Attachment 1

July 26, 2019

Subject: Review of Closure Permit Application and Other Pertinent Materials
Plant Scherer Ash Pond 1

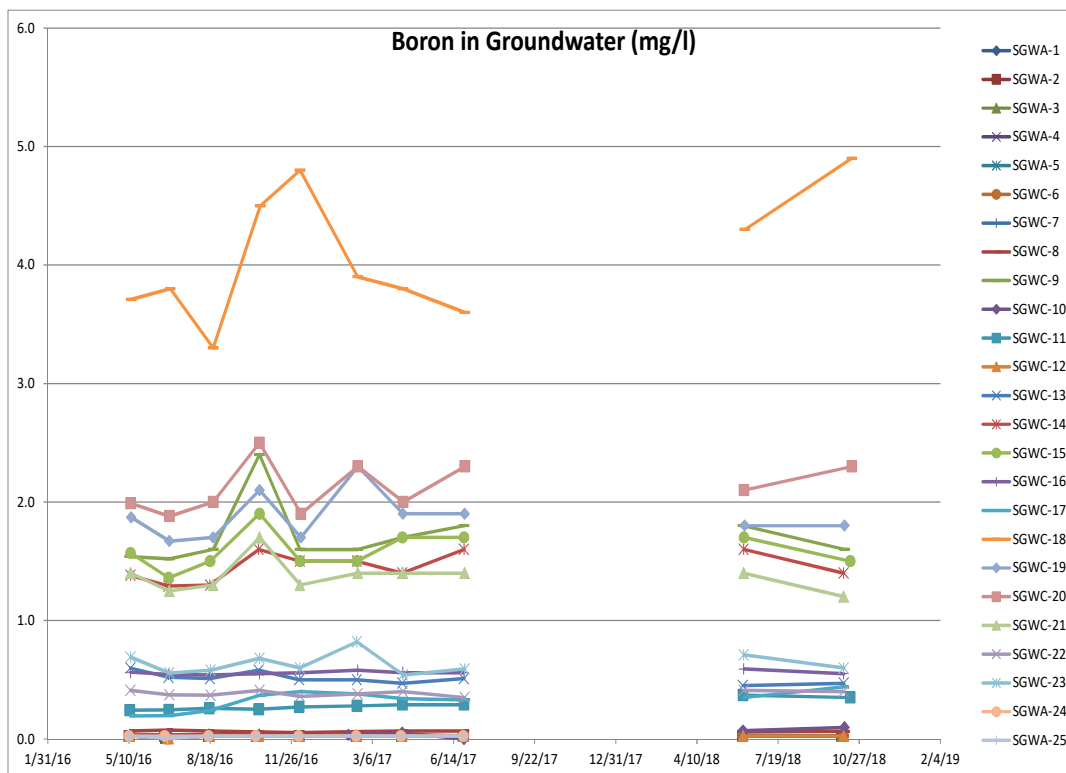
SGWC-17, SGWC-18, SGWC-19, SGWC-20, SGWC-21, SGWC-22, and SGWC-23. The time versus concentration plot of Boron concentrations in groundwater (below) illustrates the variation in groundwater quality impacts between wells.

Monitoring well SGWC-18 is the most highly impacted of the monitoring wells, with concentrations of cobalt, boron, sulfate and TDS notably higher than the other monitoring wells. A statistically significant increase in Cobalt²⁶ was documented in the 2018 annual monitoring report.²⁷ Well SGWC-18 is located off the southeast corner of the impoundment at end of the dam.
